Access Compliance Report

Public Rights-of-Way

(Curb Ramps)

Intersection ID: 31581	Main Street: BLYTHEDALE_DR	Cross Street: PATTONSBURG_DR	Location: NE
ADA ID: B55E0E34FBEC	Ramp Type: PerpDiag	Initial Pass/Fail: Fail	Overall Compliance: No
Severity Score: 8.75			
Codes/Mitigation Info/Possible Solution		Field Measurements/Component Compliance

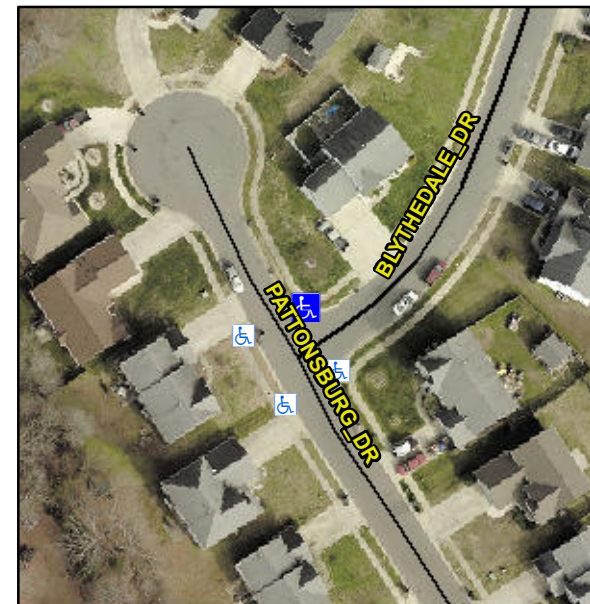
Not Found, R304.5.1

Compliance	Description	Data	Compliance	Description	Data
N/A	Ramp Length (in)	45.0	Yes	Ramp Slope (%)	5.2
No	Ramp Width (in)	40.0	Yes	Ramp XSlope (%)	0.3
N/A	Flare Type LT	N/A	N/A	Flare Type RT	N/A
N/A	Flare Slope LT (%)	N/A	N/A	Flare Slope RT (%)	N/A
N/A	Flare Traversable LT?	N/A	N/A	Flare Traversable RT?	N/A
N/A	Landing Length (in)	N/A	N/A	DWS Provided?	N/A
N/A	Landing Width (in)	N/A	N/A	DWS Contrast?	N/A
N/A	Landing Slope (%)	N/A	N/A	DWS Length (in)	N/A
N/A	Landing X Slope (%)	N/A	N/A	DWS Full Width?	N/A
N/A	Landing Curb? (Y/N)	N/A	N/A	DWS Offset (in)	N/A
N/A	Shared Landing?	N/A			
N/A	Gutter Ponding?	N/A	N/A	Gutter Slope (%)	N/A
N/A	Gutter Lip Ht (in)	N/A	N/A	Gutter X Slope (%)	N/A
N/A	Painted X Walk1?	No	N/A	Painted X Walk2?	No
	X Walk 1 Direction	To W		X Walk 2 Direction	To S
N/A	X Walk 1 Width (in)	N/A	N/A	X Walk 2 Width (in)	N/A
	X Walk 1 Slope (%)	4.5		X Walk 2 Slope (%)	2.2
	X Walk 1 X Slope (%)	1.0		X Walk 2 X Slope (%)	2.3

N/A	Ramp inside XWalk1?	N/A	N/A	Ramp inside XWalk2?	N/A
	Road Slope (%)	0.8	N/A	Clear Space?	N/A
	Road X Slope (%)	3.3	N/A	Clear Space to XWalk (in)	N/A
N/A	Any Obstructions?	N/A	N/A	Storm Grate/Utility Hazard?	N/A
	Obstruction Type			Storm Grate/Utility Type	
		N/A			N/A
		Yes		Surface Condition? (G/P)	Good

Remove & Replace Curb Ramp With Two New Directional Ramps or Equivalent.
